# CERTIFICATE OF APPROPRIATENESS PLACARD

1012 W CABARRUS STREET

- Install additional window on rear elevation
- Replace in-kind damaged cedar shake siding on west elevation

RHDC – COA Minor Work – Window and Siding Improvements – 1012 W. Cabarrus

**Proposed rear elevation with 3' casement addition in line with existing transom**

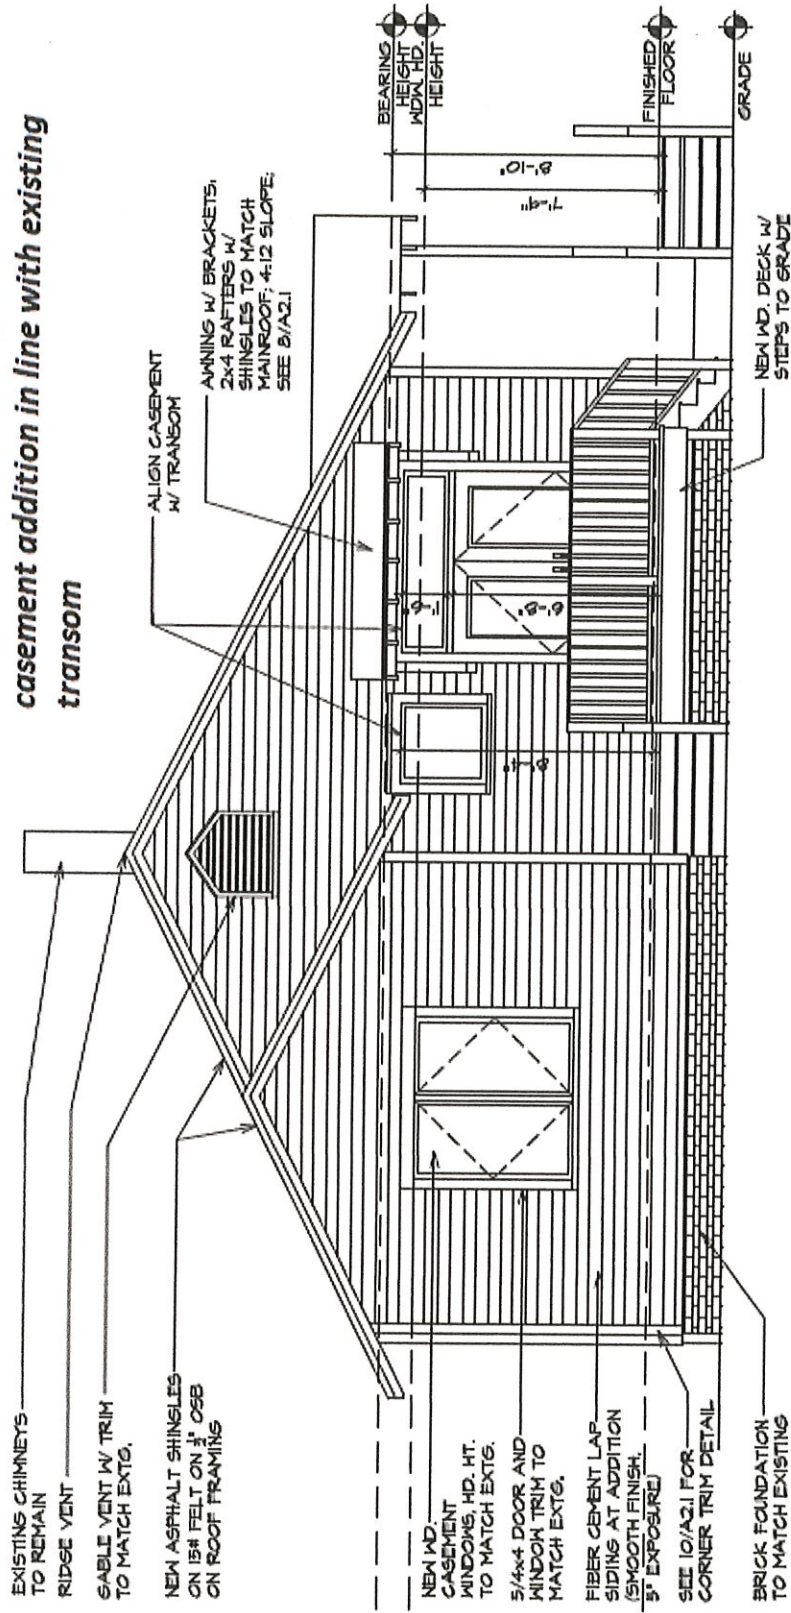
- Additional 3' Casement Window on rear façade of previously approved addition (COA 125-17-CA)

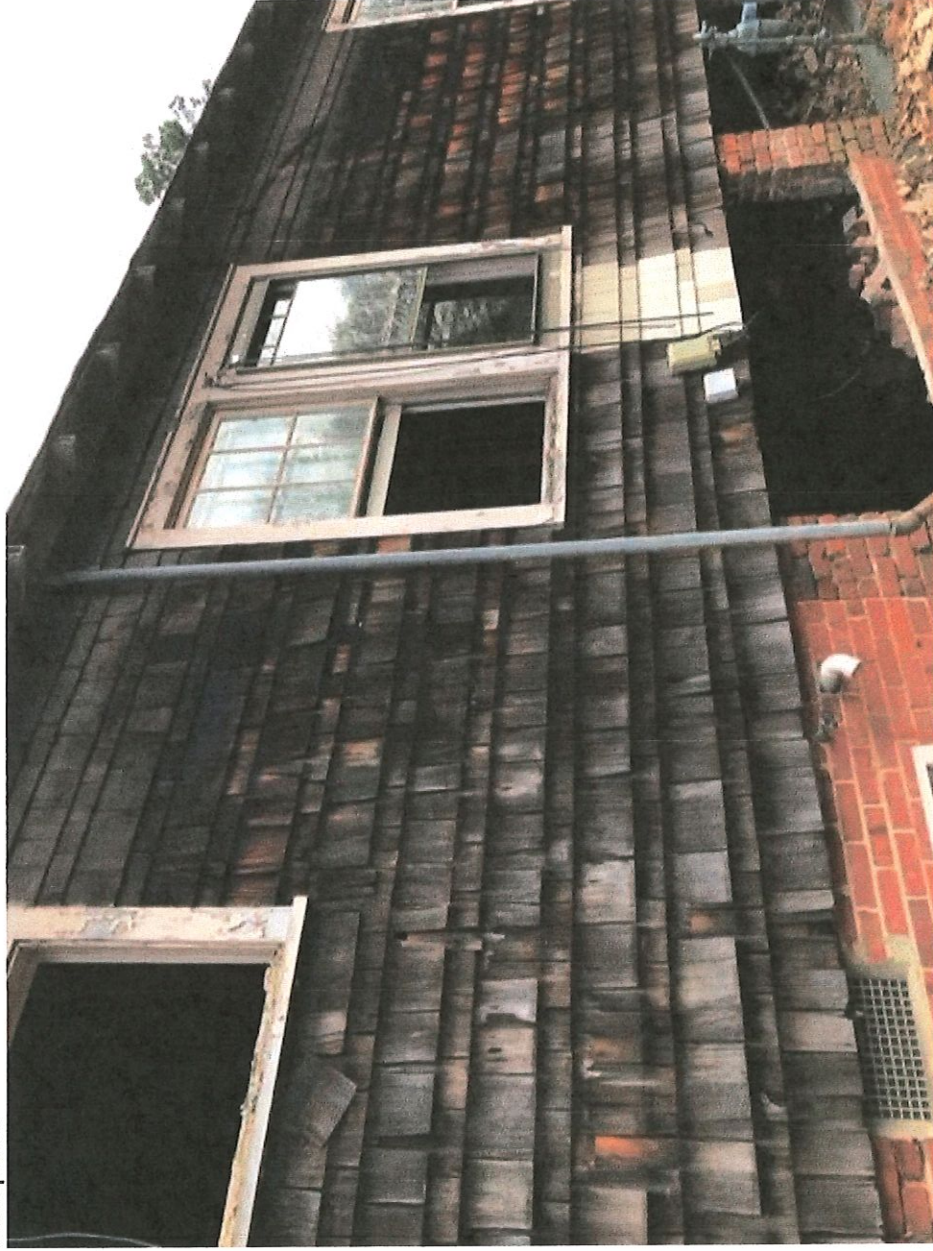
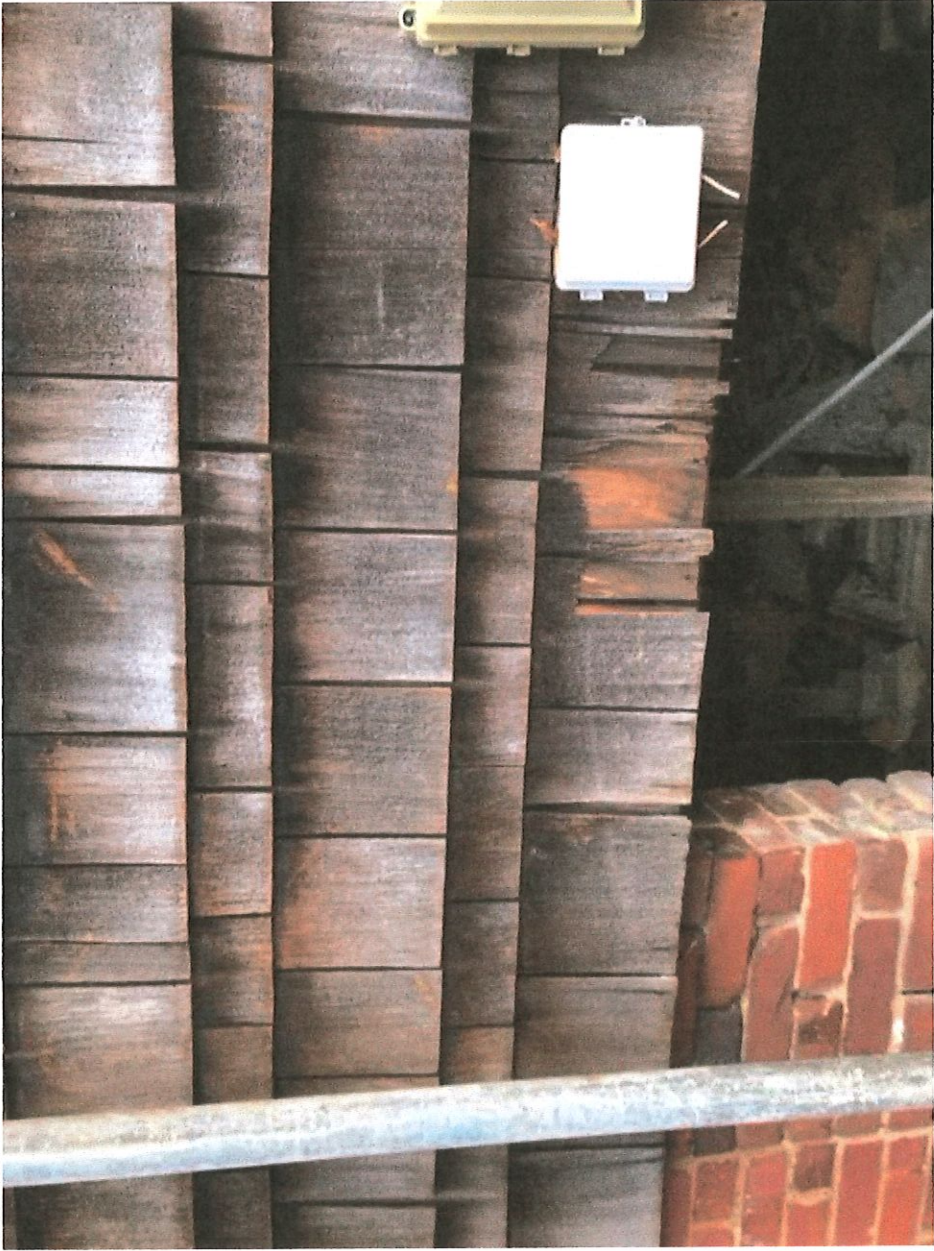
Multiple representatives of greyHouse Inc. have performed site inspections of the existing cedar shake siding as well as the wood slat backing currently installed on the house. The existing siding material currently installed throughout the exterior of the house is damaged beyond repair and will need to be replaced in order to maintain the best protection of the home. Years of exposure to the elements have resulted in rot & disintegration that compromise the integrity of the existing siding product. The extent and breadth of deterioration makes saving part or all of the existing siding material not possible at this time.

Based on this assessment, greyHouse Inc. recommends the existing cedar shake siding be replaced in full with a like product, which is to mimic the existing siding in material, size, shape, reveal, profile, etc as close as possible in all ways. At the time of replacement it is also recommended that the wood slatboard to which the existing siding is currently affixed also be removed and replaced with OSB sheathing & Housewrap to best protect the integrity of the house, limit moisture & insect penetration, and offer better insulation. Not only will OSB sheathing – the current construction standard – provide the benefits listed above but it will also accommodate the mimicking of trim profile & reveal around existing windows and doorways as it will take the place of the existing slatboard to which the siding is currently affixed.

Thank you for the follow-up email. Based on the evidence provided by the Bullard's in their prior emails and your professional judgment, pending photographs of the west side, staff is comfortable approving the replacement if that side only.
